**GULF STATES UTILITIES COMPANY**

February 1, 1985  
RBG-20046  
File No. G9.5, G9.8.6.2

River Bend Station - Unit 1  
Docket No. 50-458

Enclosed is Gulf States Utilities Company (GSU) response to the Nuclear Regulatory Commission's (NRC) Request for Additional Information (RAI) on the Initial Test Program from Mr. A. Schwencer (NRC) to Mr. W. J. Cahill (GSU) dated November 5, 1984. This response also addresses Safety Evaluation Report (SER) Confirmatory Item #61 - Initial Test Program Revisions (SER Section 14, pg. 14-3) and Generic Letter 83-24. Attachment 1 summarizes the responses to each RAI while revisions to the Final Safety Analysis Report (FSAR), as contained in Enclosures 1 through 4, provide the necessary supporting statements which will be incorporated in a future amendment.

FIGURE 14.2-6

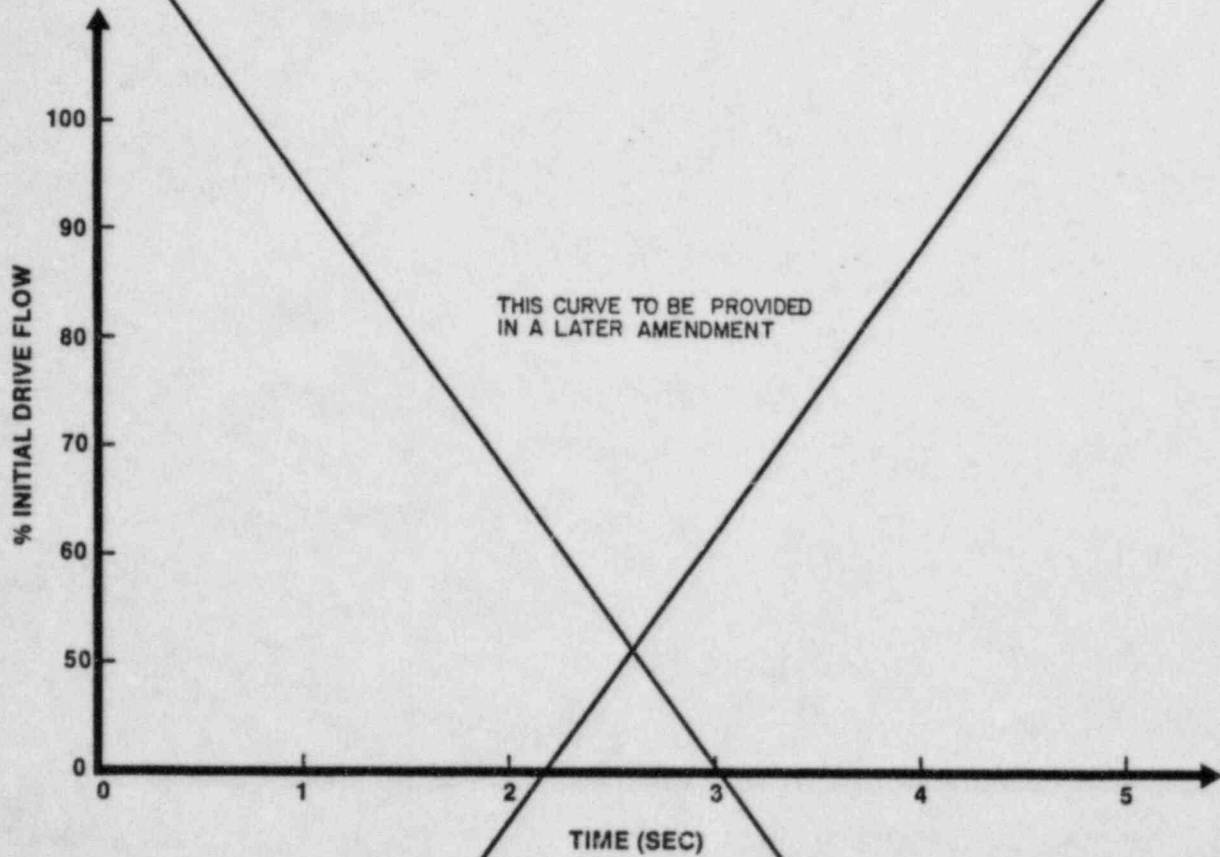
5. Item 14A: FSAR Figure 14.2-6, "Maximum Acceptance Drive Flow Following Pump Trip," should be provided or an appropriate document should be referenced.

Response: The General Electric Company's (GE) Transient Safety Analysis Design Report (TSADR) (NEDC-30877) contains the figure(s) required to determine maximum acceptable drive flow following a recirculation pump trip and will be available in March 1985. Therefore FSAR Figure 14.2-6 will be deleted (see Enclosure 4.)

DELETE THIS  
FIGURE
